SLUP-9 (2009)

JAMES T. HAWLEY
 PLOT PLAN FOR
TERRAIN SOLUTIONS, LLC.
 P.O. BOX 386
 CONLEY, GEORGIA 30148
 (770) 488-5000
 www.terrainllc.com

PETITION NO: SLUP-9

PROPOSED USE: Wood Products
Processing

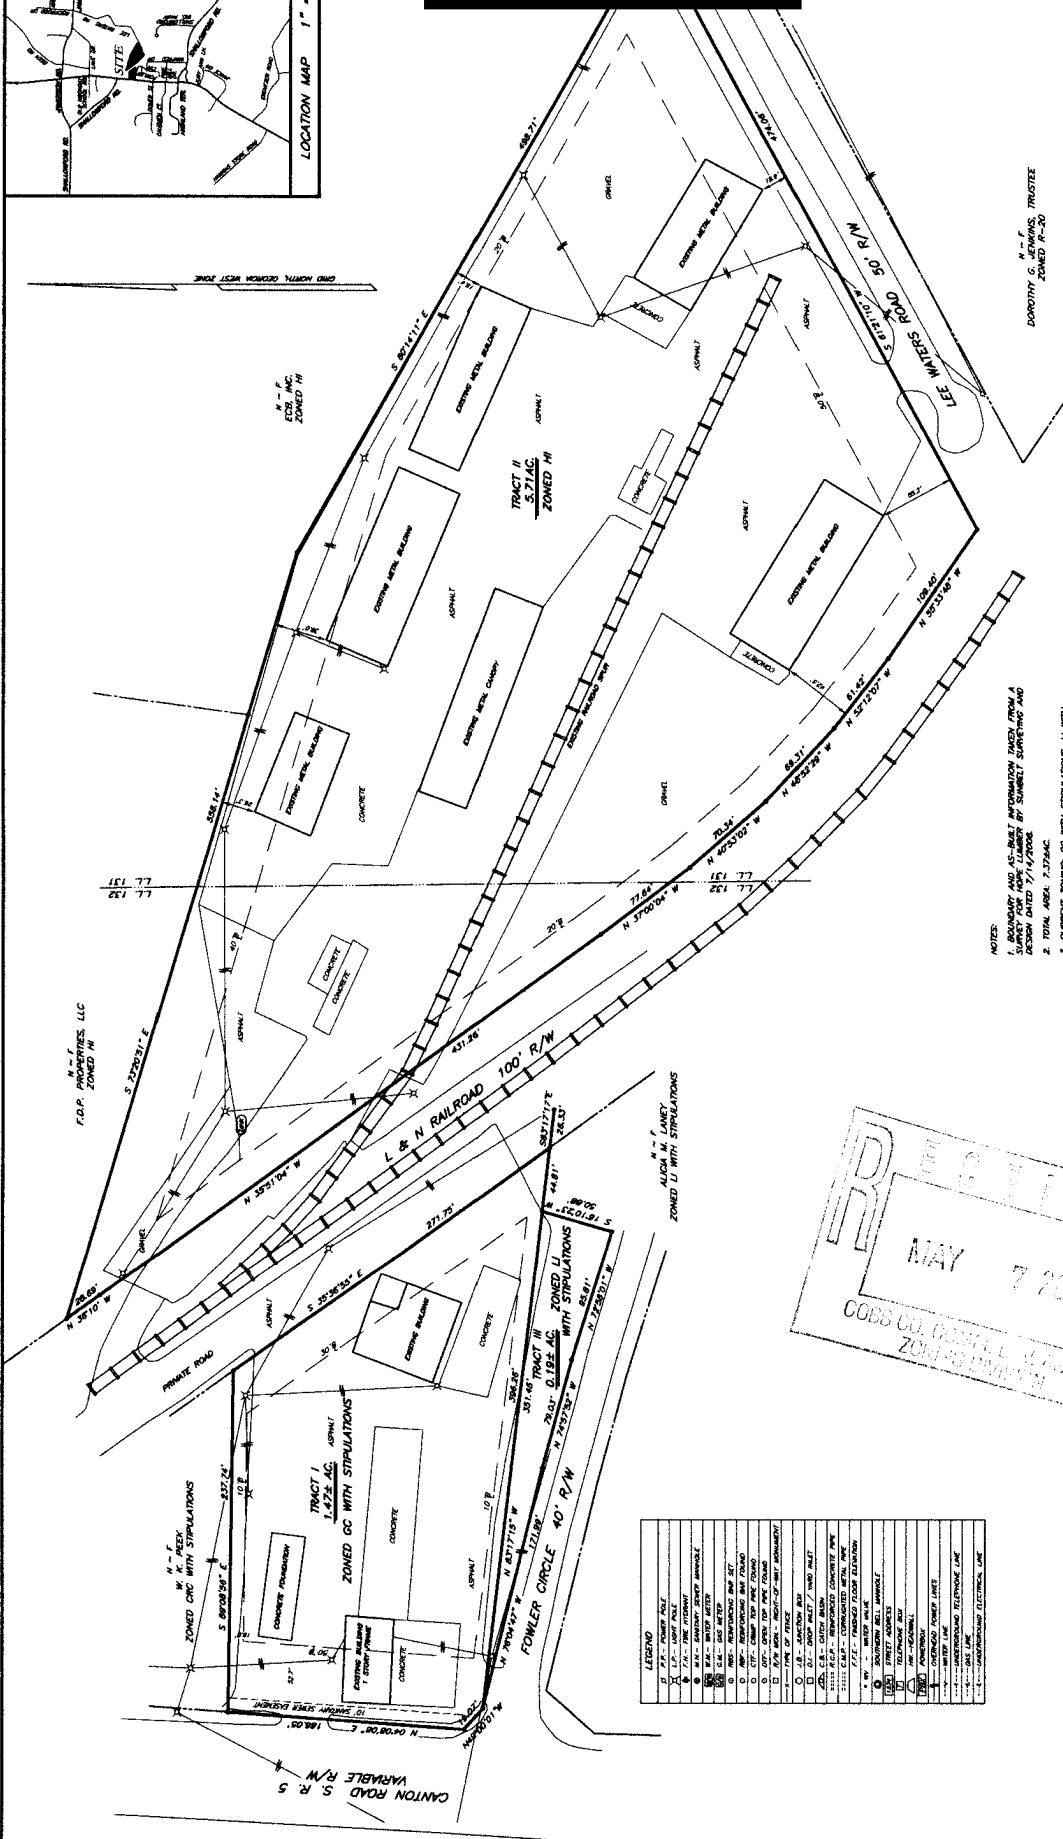
Water available to site on W side and also on E side of RR tracks; records show 4586 Canton Rd connected. Sewer available to tract W of RR tracks, & records show 4586 Canton Rd connected. Sewer not available to tract E of RR tracks; Health Dept approval required on ongoing basis for any septic system on this tract. No new buildings proposed.

Recommend applicant consider entering into a development agreement pursuant of O.C.G.A. 36-71-13 for dedication of the following system improvements to mitigate traffic concerns: a) donation of right-of-way on the east side of Canton Road, a minimum of 50' from the roadway centerline.

Recommend applicant consider entering into a development agreement pursuant of O.C.G.A. 36-71-13 for dedication of the following system improvements to mitigate traffic concerns: a) donation of right-of-way on the north side of Fowler Circle, a minimum of 25' from the roadway centerline.

Recommend closing Fowler Circle driveway.

Recommend installing sidewalk, curb and gutter along the road frontages.

Recommend restricting truck access to Lee Waters Road.

All access roads shall have an all weather driving surface capable of supporting 75,000 pounds with an unobstructed width of not less than 20 feet, 25 feet inside turning radius, 50 foot outside turning radius and unobstructed vertical clearance of not less than 13 feet 6 inches.

Access road shall extend to within 150-feet of all portions of the facility or any portion of the exterior wall of the first floor.

- Provide comprehensive hydrology/stormwater controls to include development of out parcels.
- Submit all proposed site improvements to Plan Review.
- Any **spring activity** uncovered must be addressed by a qualified geotechnical engineer (PE).
- Structural fill _____ must be placed under the direction of a qualified registered Georgia geotechnical engineer (PE).
- Existing facility.
- Project must comply with the Water Quality requirements of the CWA-NPDES-NPS Permit and County Water Quality Ordinance.
- Water Quality/Quantity contributions of the existing lake/pond on site must be continued as baseline conditions into proposed project.
- Calculate and provide % impervious of project site.
- Revisit design; reduce pavement area to reduce runoff and pollution.

- No Stormwater controls shown _____
- Copy of survey is not current - Additional comments may be forthcoming when current site conditions are exposed.
- No site improvements showing on exhibit.

1. It is anticipated that the site will be utilized with no significant modifications. However, any site changes must be approved through the County's Plan Review Process and meet all County Code and Development Standards.
2. There is an existing above ground storage tank located on the site near the northern entrance to Tract 2. This tank must be removed or replaced with proper spill protection provided.
3. A Notice of Intent must be filed with the Georgia Environmental Protection Division for coverage under the NPDES General Permit to discharge stormwater associated with industrial activity. This facility will likely be classified under SIC Code 24 for Lumber and Wood product operations.

- Site plan received by the Zoning Division on May 7, 2008;
- Access from Canton Road only, except if property is blocked by a stopped train;
- Wood chipping and grinding only;
- No burying or burning wood on site;
- Planning Division comments;
- Water and Sewer comments and recommendations;
- Stormwater Management comments and recommendations; and
- DOT comments and recommendations.
